Official Notification - Federal Boat Safety Act Flywheel Replacement 1994 and 1995 9.9 and 15 HP Models

1994 and 1995 Force, Gamefisher and Zodiac

FIGURE 1. FLYWHEEL

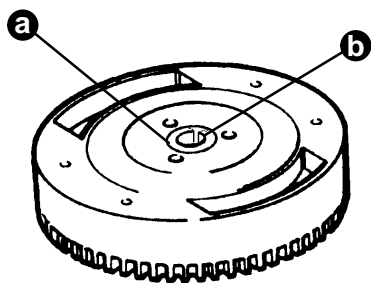
Flywheel hubs may have been produced with an incorrect grade of steel. Cracks could develop in the hub and cause the flywheel to become loose on the crankshaft. The crankshaft or the flywheel could break and become detached from the engine. Figure 1 shows where cracks could develop on the flywheel hub.

FIGURE 3. REPLACEMENT FLYWHEEL

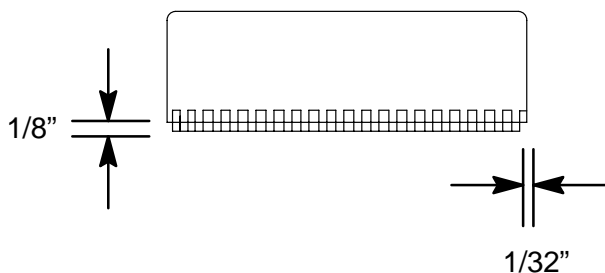
The replacement flywheel has a 1/32" deep by 1/8" high machined step on the ring gear teeth as shown in Figure 3.

Outboards repaired at the factory and identified with the blue dot on the engine carton label do not have flywheels with this machined step but are OK to use (see figure 2).

FIGURE 4. REVERSE LOCK LEVER DECAL

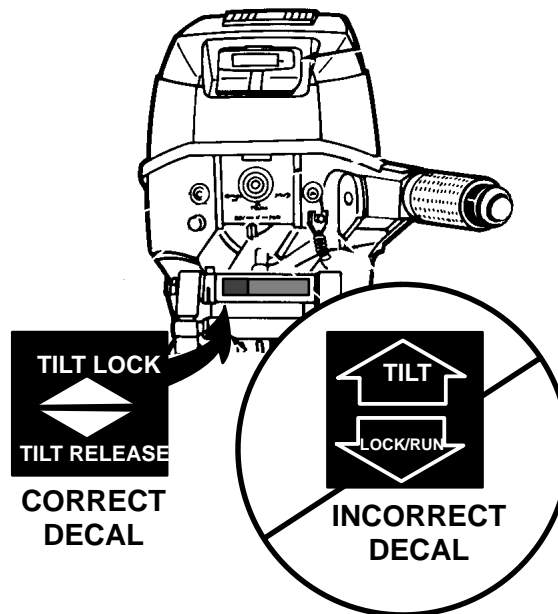
An incorrect tilt lock lever decal may have been assembled to some of these engines. The incorrect decal indicates the wrong direction to lock and release the reverse-lock feature. The correct decal and the incorrect decal are shown in Figure 4.

Inspect engines within this serial number range and replace the incorrect decal with P/N F688585 as necessary. Remove the incorrect decal, attach the correct decal in place. Enclosed with this bulletin are 3 decals P/N F688585.
